| APPLICATION NO. | FILING DATE | FIRST NAMED INVENTOR | ATTORNEY DOCKET NO. | CONFIRMATION NO. |
|-----------------|-------------|----------------------|---------------------|------------------|
| 10/551,134 | 09/29/2005 | Dennis Karlsson | 95-725-P1791 | 4299 |

| Office Action Summary | Application No. | Applicant(s) | |

DETAILED ACTION

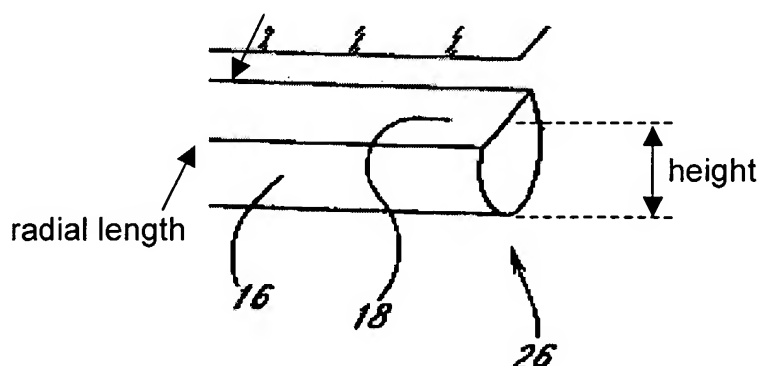
- The convex front side (16) is in direct communication with the rear side (18) (col. 10, lines 4-8);
- The convex front side (16) has a radius and a height (as shown in the following picture) being measured perpendicular to the rear side;

- The height is at least $\frac{1}{4}$ of a radius length (as shown in the above picture) of the rear side (18);
- The front surface (16) extends between two opposing side surfaces (20, 22);
- The lighting guiding material (14) has a rod shape (Fig. 2); and
